MODIFICATION BULLETIN NO. IFO-001ISSUED ON Feb. 29, 1996

Model	IFO					Date of Modification	
Modified Article	Bottom Plate & Paper Tray Case					Execution Date	
Reason for Modification	<input checked="" type="checkbox"/> Parts catalog correction <input type="checkbox"/> To meet standards () <input type="checkbox"/> To facilitate assembly <input type="checkbox"/> Vender change <input type="checkbox"/> Part standardization <input type="checkbox"/> To improve reliability <input type="checkbox"/> Other					From 1st mass production	
Old Part No.	New Part No.	Description	Q'ty Used Old → New	Interchange- ability	Remarks	Parts Catalog	
						Index No.	Page
(H505-20, -21, -27, -28)							
H505 3010	H505 3012	Bottom Plate	1 → 1	X / O		6	1-7
H505 3103K	H505 3103L	Paper Tray Case	1 → 1	X / O		7	1-7
(H505-30, -33, -40, -43, -51, -53, -59, -60, -63)							
H505 3103K	H505 3103L	Paper Tray Case	1 → 1	X / O		7	1-7

MODIFICATION BULLETIN NO. IFO-005ISSUED ON Mar, 15, '96

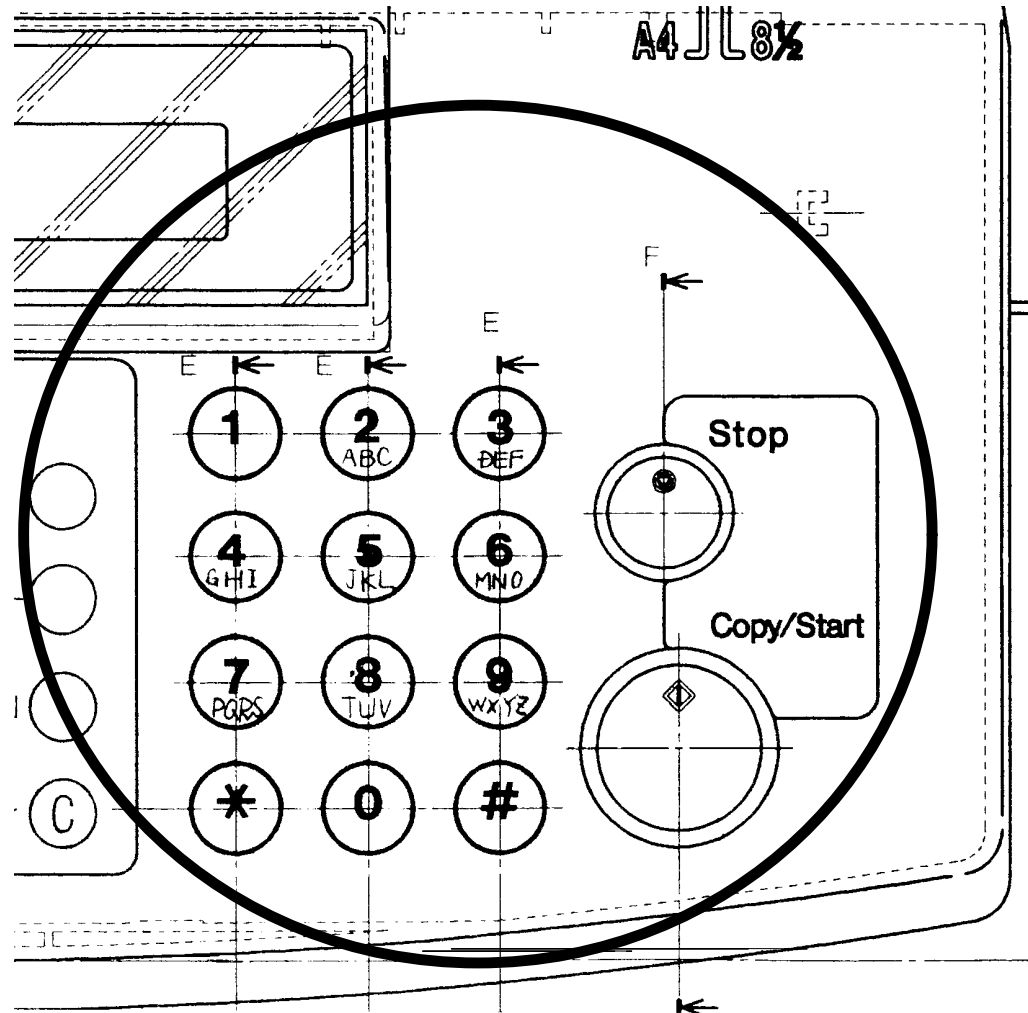
Model	IFO (Asia only)					Date of Modification	
Modified Article	Op-prot Ass'y - ASIA					Execution Date	
Reason for Modification	<input type="checkbox"/> Parts catalog correction <input checked="" type="checkbox"/> To meet standards () <input type="checkbox"/> To facilitate assembly <input type="checkbox"/> Vender change <input type="checkbox"/> Part standardization <input type="checkbox"/> To improve reliability <input type="checkbox"/> Other					From February Production '96	
<p>The alphabet has been added to the key-pad. It is needed in Singaporre to sell the machine from April '96.</p>

Old Part No.	New Part No.	Description	Q'ty Used Old → New	Interchange- ability	Remarks	Parts Catalog	
						Index No.	Page
(H505-51)							
H5054022B	H5054022C	Op-port Ass'y - ASIA	1 → 1	X / O		1	1-5
(H505-59)							
H5054055B	H5054055C	OP-port Ass'y - ASIA	1 → 1	X / O		1	1-5

MODIFICATION BULLETIN NO. IFO - 010ISSUED ON Sep.15, 1996

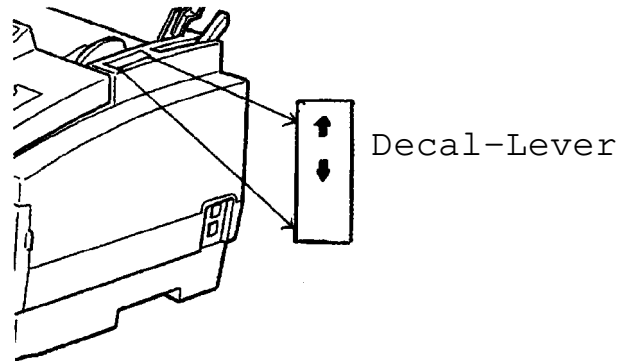
Model	IFO	Modification Schedule
Modified Article	Decal - Lever	From 1st Production in March '96.
Reason for Modification	<div><div><input type="checkbox"/> Parts catalog correction</div><div><input type="checkbox"/> Vender change</div><div><input type="checkbox"/> To meet standards ()</div><div><input type="checkbox"/> Part standardization</div><div><input type="checkbox"/> To facilitate assembly</div><div><input checked="" type="checkbox"/> To improve reliability</div><div><input type="checkbox"/> Other</div></div> <div>A decal has been added to remind the user to release the lever before setting paper or removing paper jams.</div>

Old Part No.	New Part No.	Description	Q'ty Used Old → New	Interchange- ability	Remarks	Parts Catalog	
						Index No.	Page
(H505 - 30, - 39, - 40, - 49, - 60, - 69)							
	H505 4257	Decal - Lever - EU	0 → 1				
(H505 - 53)							
	H505 4258	Decal - Lever - Taiwan	0 → 1				
(H505 - 20, - 21, - 27, - 28, - 51, - 59)							
	H505 4259	Decal - Lever - English	0 → 1

MODIFICATION BULLETIN NO. IFO - 011

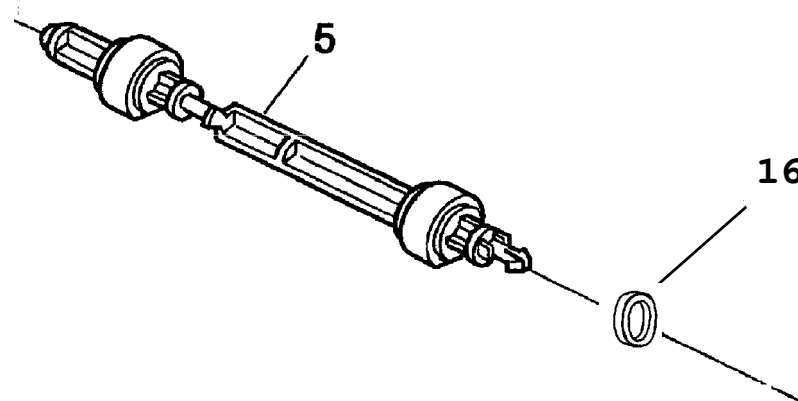
Model	IFO			Modification Schedule		
Modified Article	Collar - Feed Roller			From 1st production in March '96		
Reason for Modification	<div style="display: flex; justify-content: space-between;"> <div> <input type="checkbox"/> Parts catalog correction <input type="checkbox"/> Vender change </div> <div> <input type="checkbox"/> To meet standards () <input type="checkbox"/> Part standardization </div> <div> <input type="checkbox"/> To facilitate assembly <input checked="" type="checkbox"/> To improve reliability <input type="checkbox"/> Other </div> </div> <p>A collar has been added at the right of the feed roller. It prevents the feed roller from sliding to the right when the operator opens the upper cover and touches the feed roller for removing jammed paper.</p>

Old Part No.	New Part No.	Description	Q'ty Used Old → New	Interchange-ability	Remarks	Parts Catalog	
						Index No.	Page
	H5053135	Collar - Feed Roller	0 → 1			16	6

MODIFICATION BULLETIN NO. IFO - 012

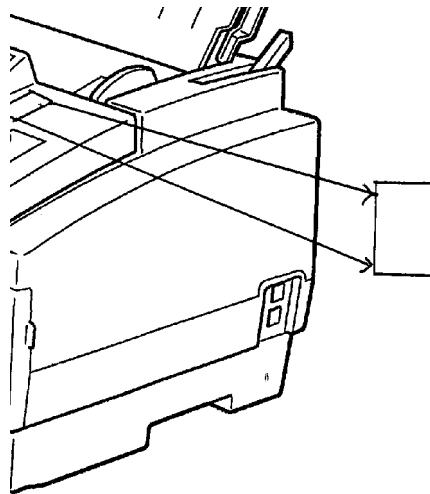
Model	IFO		Modification Schedule
Modified Article	Decal - Op Port		From 1st production in May '96.
Reason for Modification	<div style="display: flex; justify-content: space-between;"> <div> <input type="checkbox"/> Parts catalog correction <input type="checkbox"/> Vender change </div> <div> <input type="checkbox"/> To meet standards () <input type="checkbox"/> Part standardization </div> <div> <input type="checkbox"/> To facilitate assembly <input checked="" type="checkbox"/> To improve reliability <input type="checkbox"/> Other </div> </div> <p>A decal has been added on the operation panel, warning against opening the ADF from the rear side.</p>

Old Part No.	New Part No.	Description	Q'ty Used Old → New	Interchange-ability	Remarks	Parts Catalog	
						Index No.	Page
	H505 4271	Decal - Op Port	0 → 1

Note:1

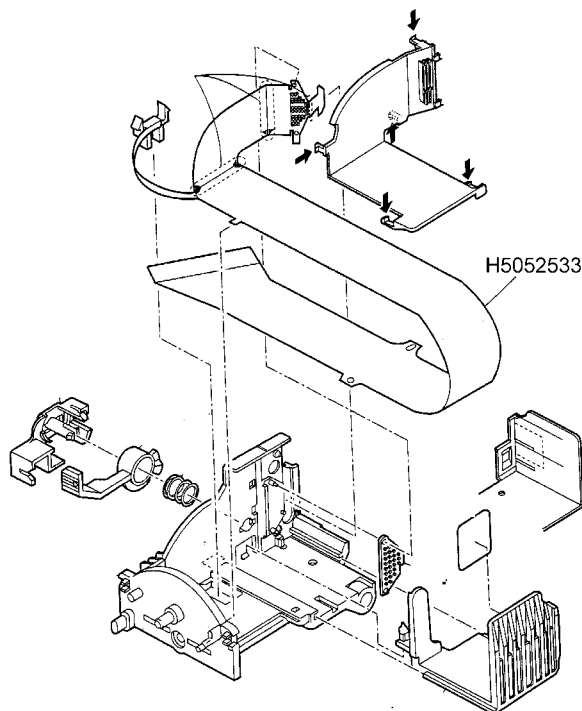
This is a component of the TIJ unit and is newly registered as a spare part because of demand from the field.

Old part number	New part number	Description	Qty	Int	Page	Index	Note
	H505 2533	Ribbon – Cable – Cartridge Ass'y	0 - 1		11	7	1
